RFI No.: 1

Project: Compton Unified School District – Bid No. 27-003, FA & Communication Systems – Multisite

Site: Compton High School

Subject: Clarification of PA System Scope and Existing/New Equipment

TE1.01

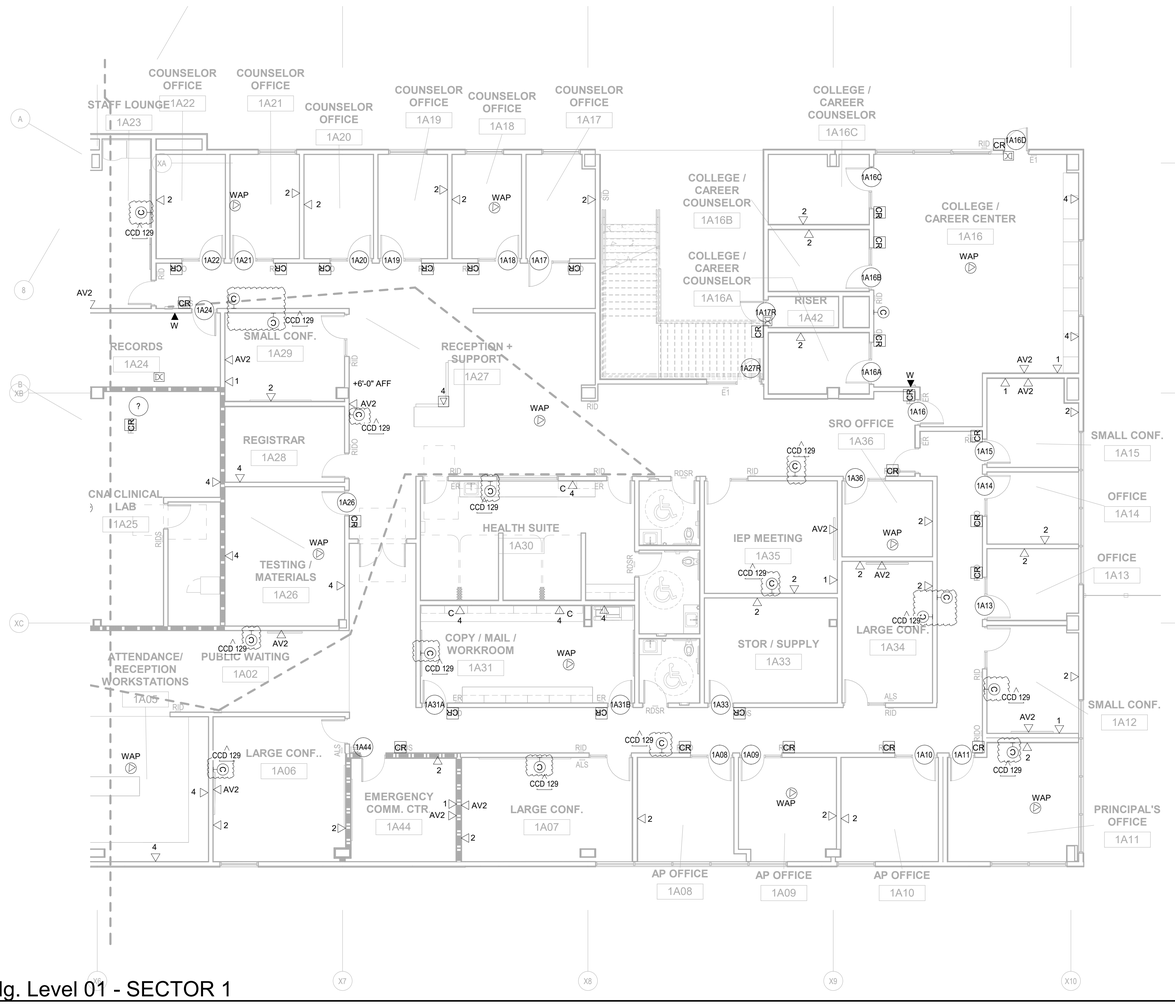
3. Confirm whether the following items shown or called out on the referenced sheets are new work under this contract or existing equipment to remain:
    - APX40TN and FS12TEN-66 outdoor speakers mounted at existing poles.

For question no. 3. All PA speakers and PA combination speaker/clock indicated on bid documents shown with 'CLOUDS' ARE ALL NEW / to be added as part of this scope of work. No Exceptions. Specified outdoor speakers for this scope of work are all new / to be added as part of this scope of work. Work shall include network cabling, cabling terminations, additional patch panel as needed, patch cable, network switch, back boxes, cable supports, additional controllers, servers, amplifiers and any ancillary devices, and / or required system programming for a fully functional system. Coordinate with school district for any additional license from "ATLASIED" / "DANTE' if needed.

TEA1.01

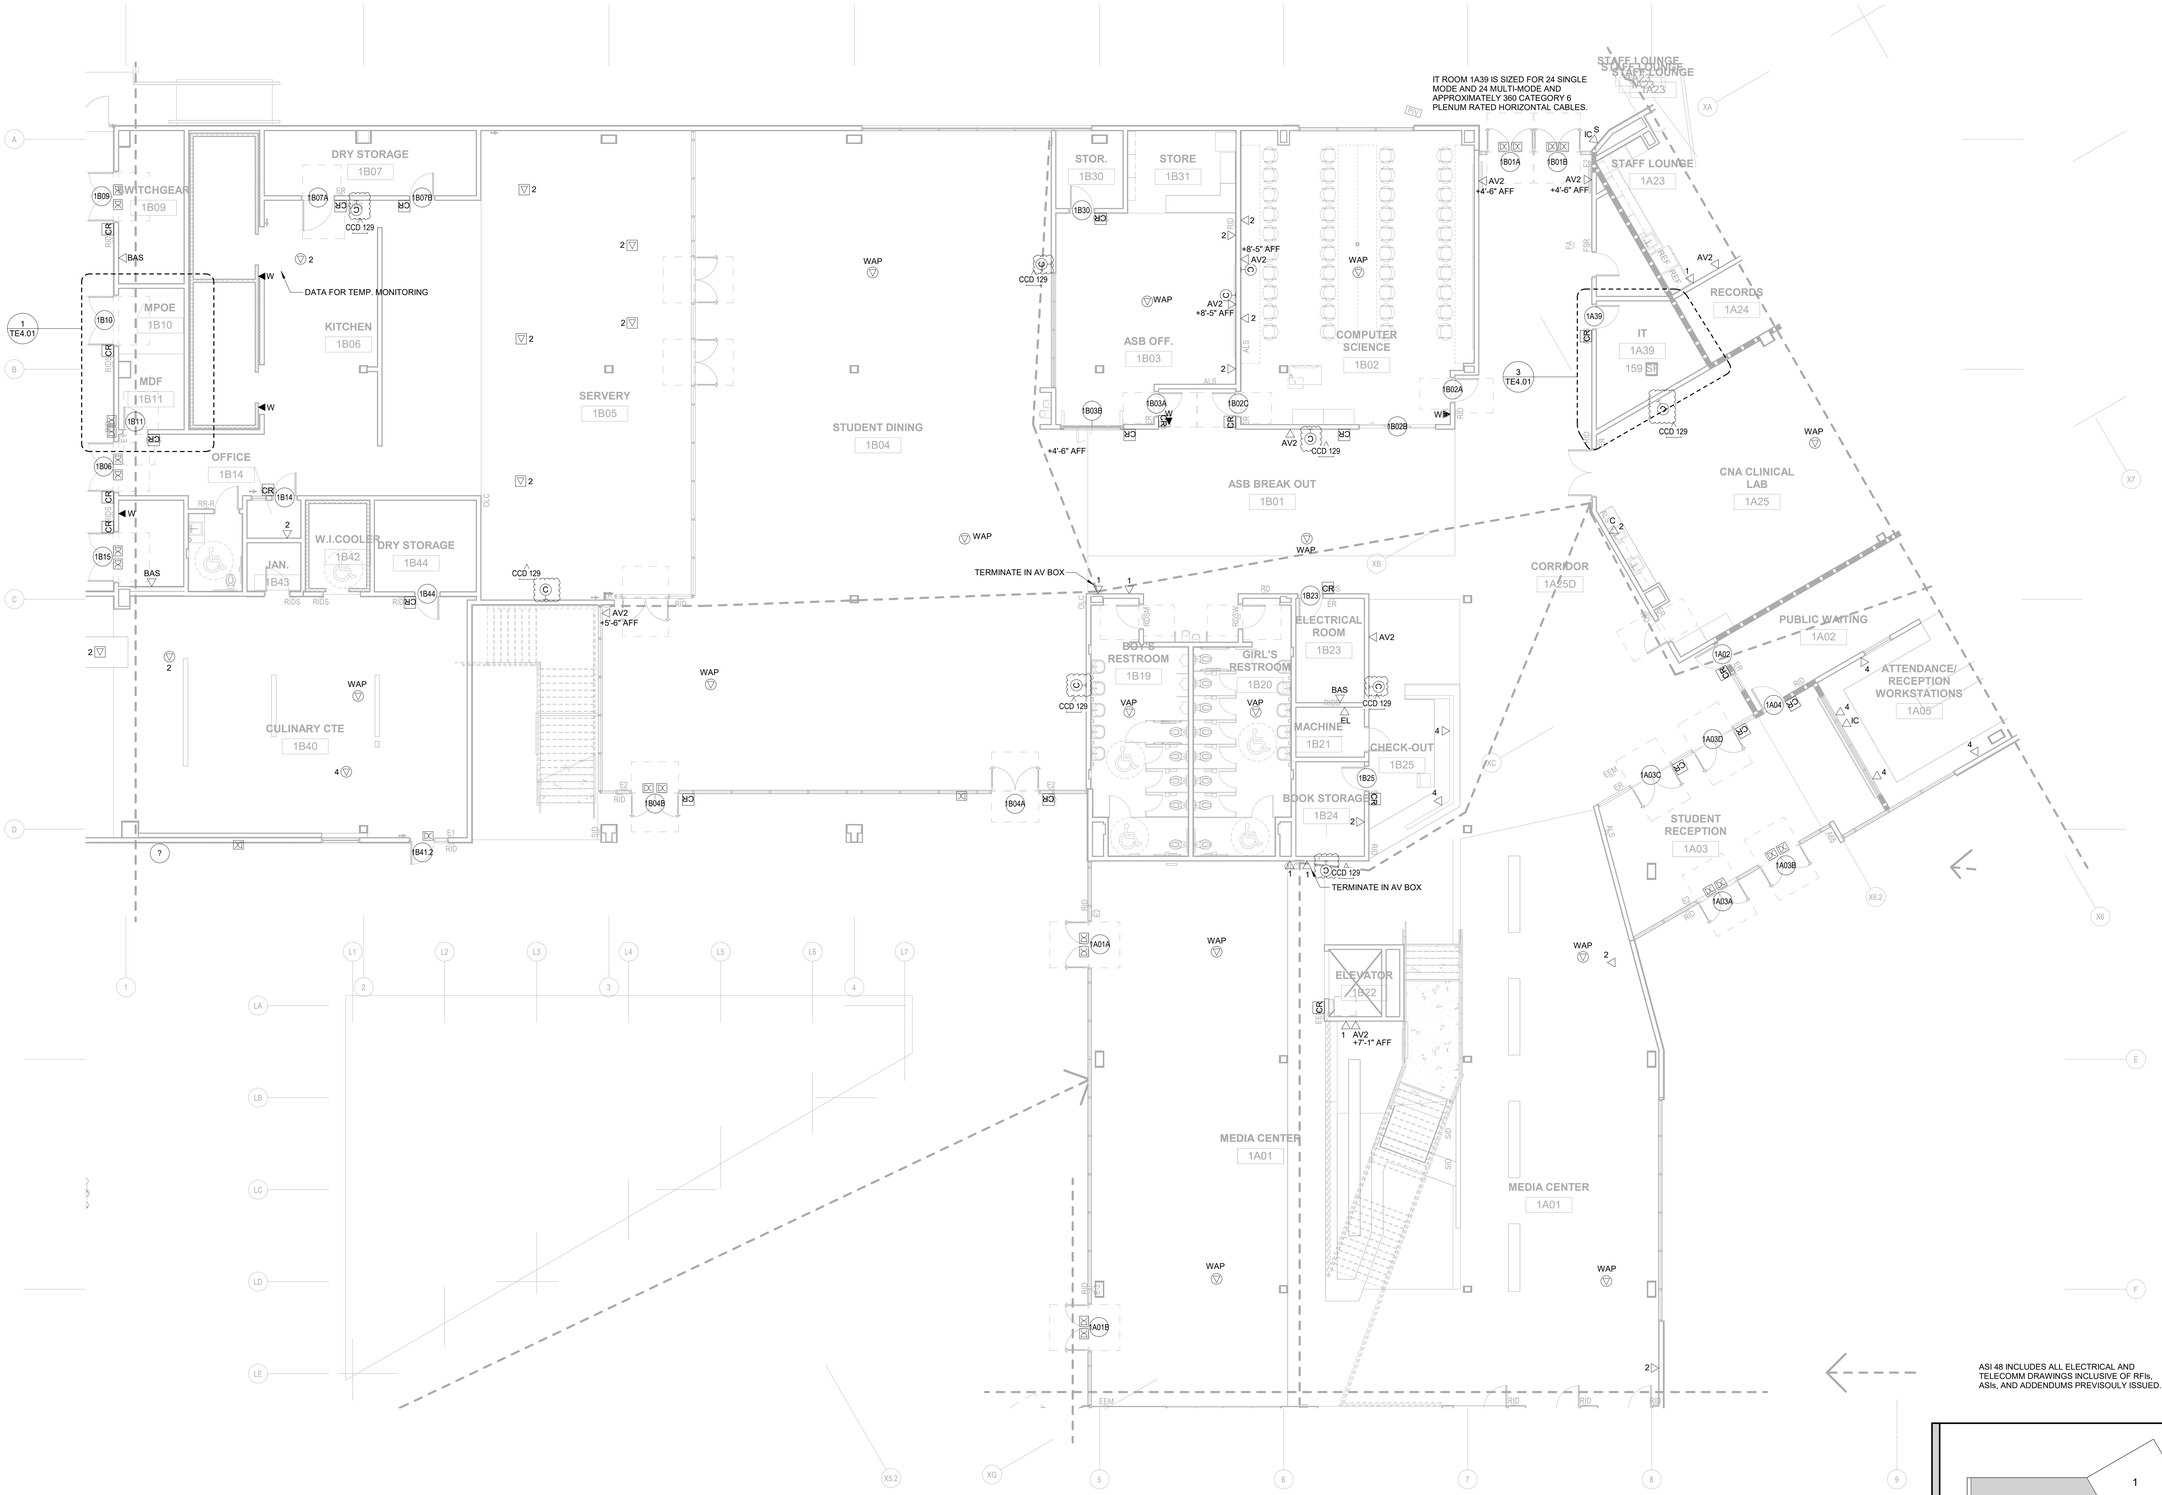
1. Confirm whether the work is limited to installing the clocks and speakers in the Administration area, with all other campus PA equipment and wiring existing and to remain.

Answers to questions above.
For question no.1 about work clarification in admin area as indicated on sheet TEA1.01. Work is to add PoE type combination PA speakers/clock as indicated on sheet TEA1.01, to match existing PA speaker/clock. Combination speaker / clock that are shown with 'CLOUDS' are to be added as part of this work. Other PA speakers and combination PA speakers / Clocks that are shown on drawing with NO CLOUDS ARE ALL EXISTING TO REMAIN, NIC. Work shall include network cabling, cabling terminations, additional patch panel as needed, patch cable, network switch, back boxes, cable supports and any ancillary devices and / or required system programming to add these PA speaker / clocks.

DATA A116 ENLARGED PLAN

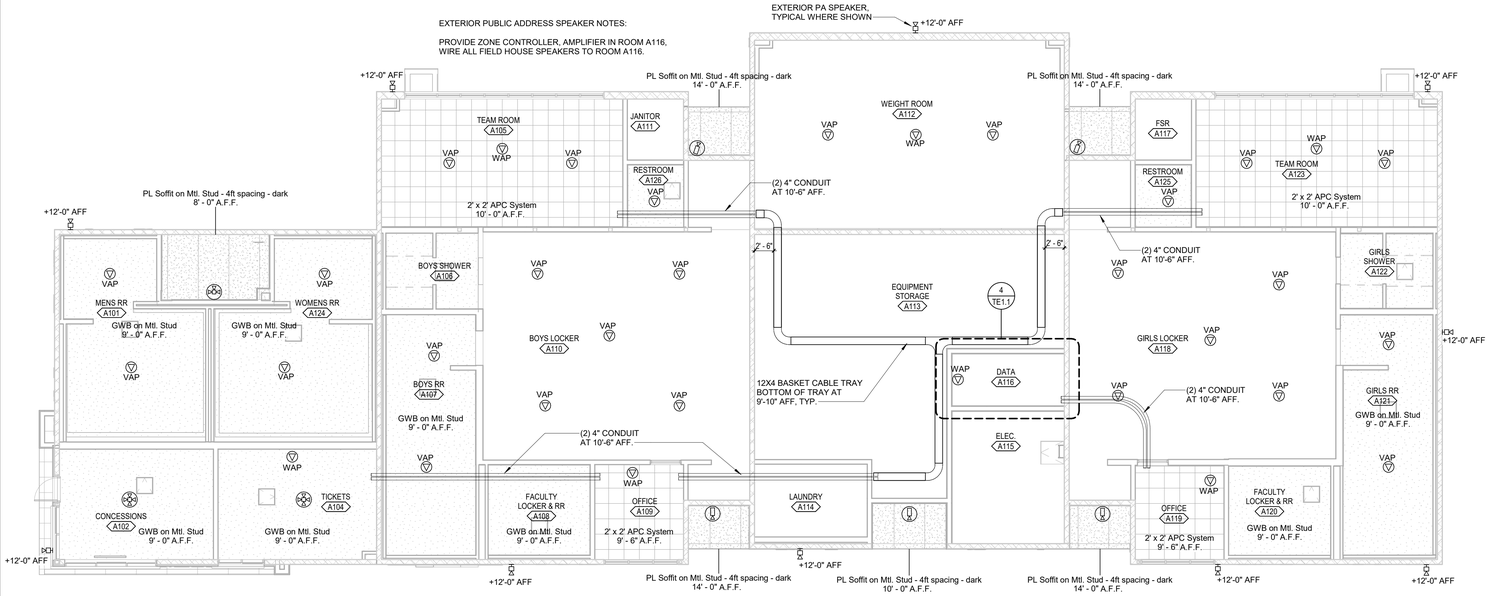
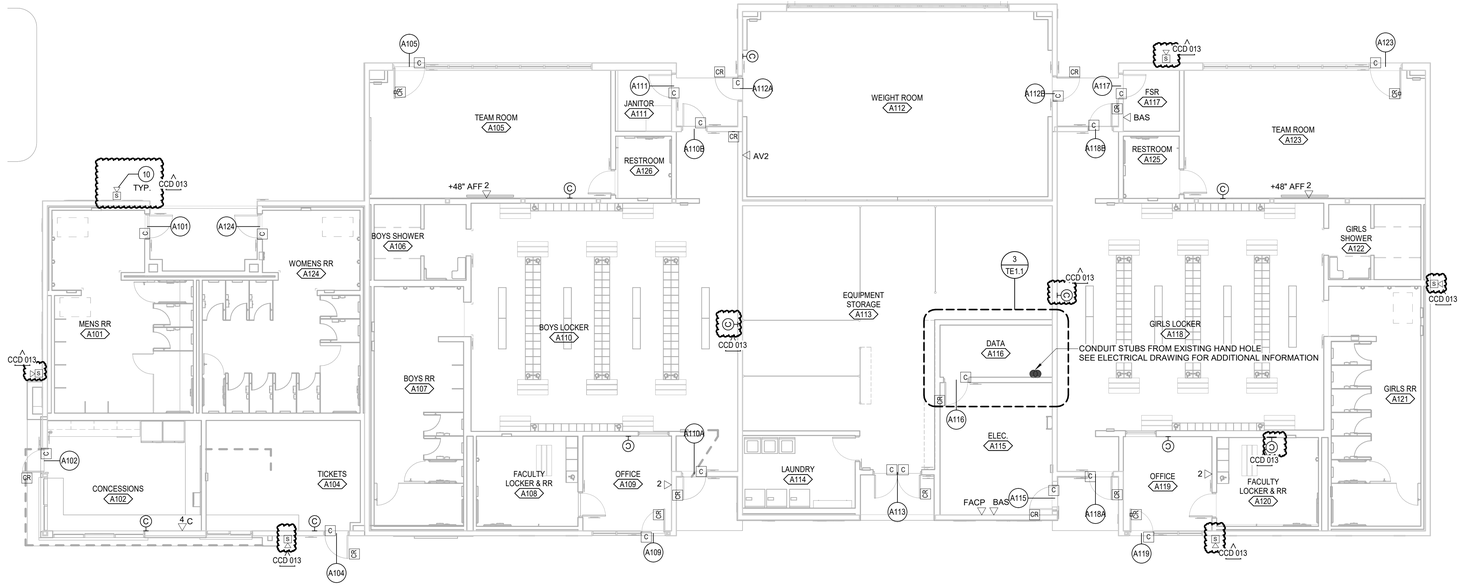
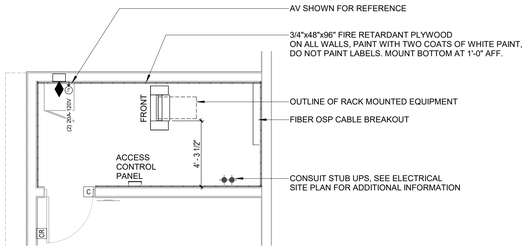
- APX40TN fieldhouse exterior speaker and connections to the athletic-field building IDF.
    - Zone controllers and amplifiers in Rooms IT 1G10, IT 1A39, IT 1C14, IT 1P10, and A116.
